FINAL PLAT

WICHITA HEIGHTS HIGH SCHOOL ADDITION

RE: SUB 2002-69 -- One-Step Final Plat of Wichita Heights High School Addition

STAFF REPORT
(ONE-STEP FINAL PLAT APPROVED 7/18/02)

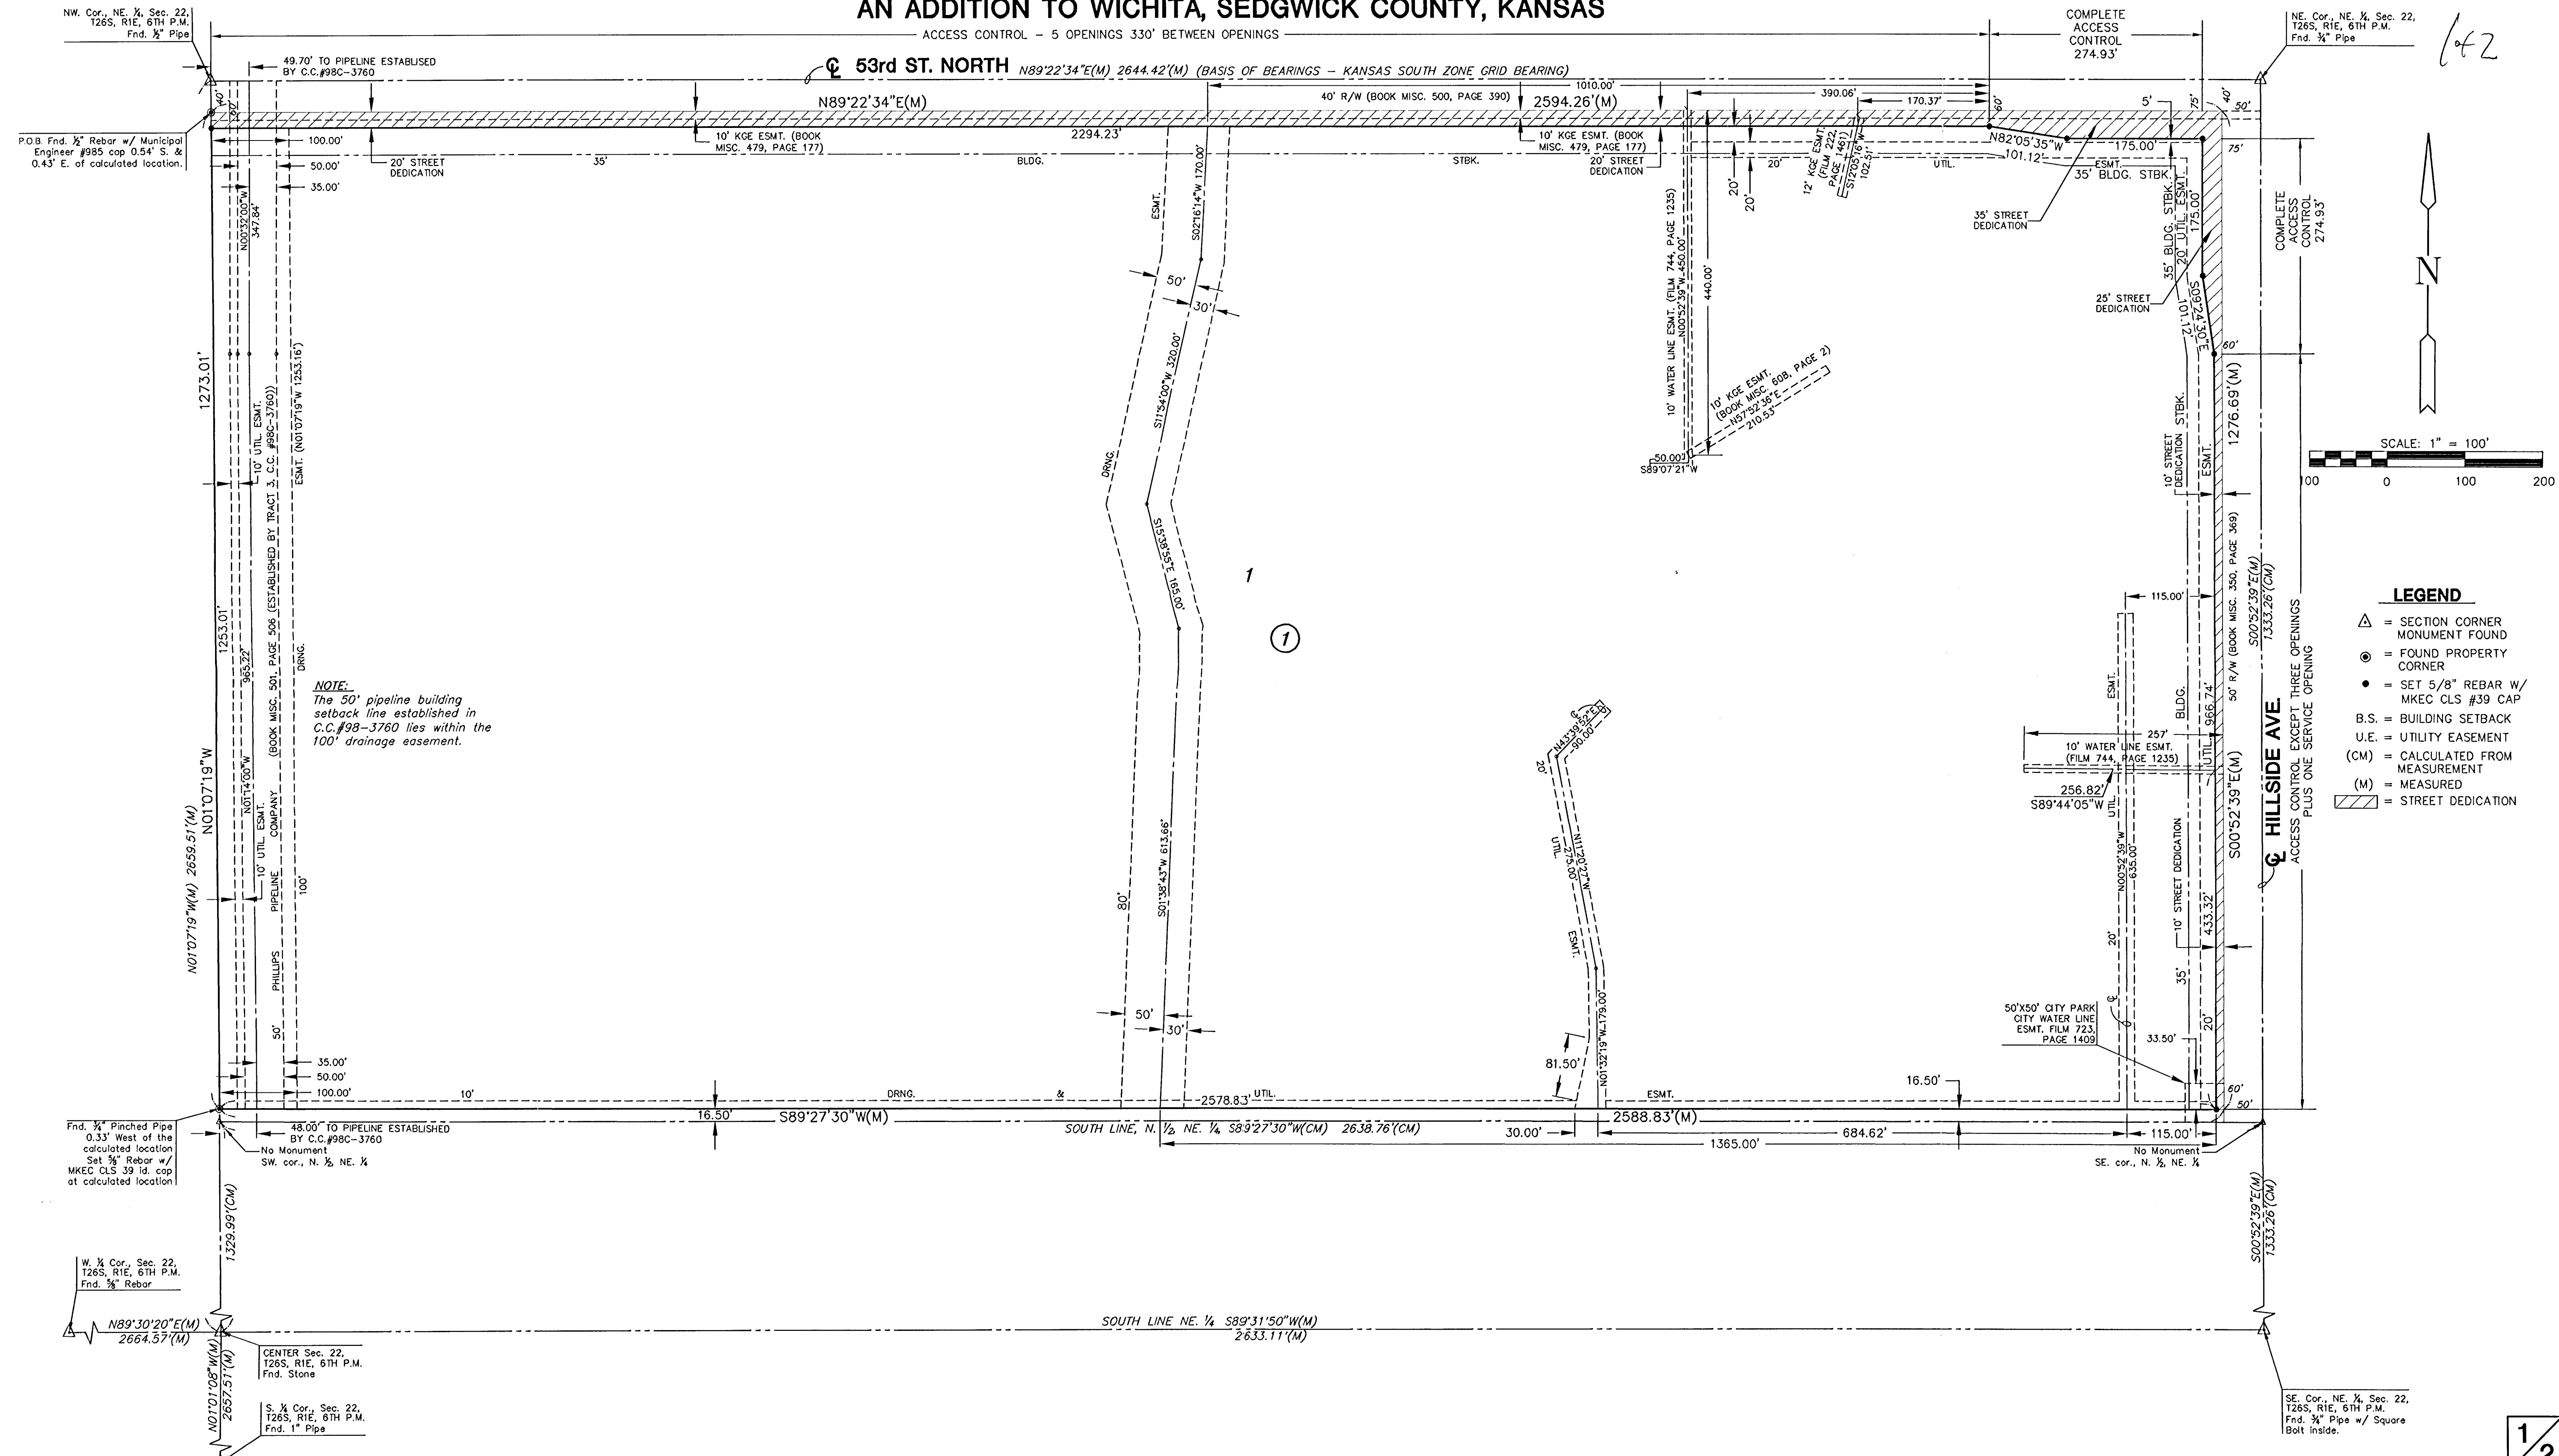
- C. City Engineering needs to comment on the status of the applicant's drainage plan. *A drainage easement or drainage reserve is requested. A drainage plan shall be provided to County Engineering for their review.*

- D. Traffic/County Engineering needs to comment on the access controls, particularly the need for minimum separation between openings. The plat proposes five access openings along both arterial streets. *Sedgwick County Public Works requests a meeting with the applicant concerning access controls. MAPD and Traffic Engineering recommend four openings (which includes one service opening) be permitted along Hillside. 660 feet between openings along 53rd St. is recommended.*

- E. The Applicant has provided a pipeline document which appears to indicate a required 50-ft setback from the pipeline located on the property. The applicant's agent shall determine if any setback requirements for the pipelines by researching the text of the pipeline agreements. If a setback from the pipeline easements is provided for in the pipeline easement agreements, it shall be indicated on the face of the plat.

- O. The representatives from the utility companies should be prepared to comment on the need for any additional utility easements to be platted on this property. Southwestern Bell requests additional easements.

ACCESS CONTROL - 5 OPENINGS 330' BETWEEN OPENINGS

- D. Four openings (which includes one service opening) shall be permitted along Hillside. 660 feet between openings is needed along 53rd St. North. *Revised (see weber memo)*
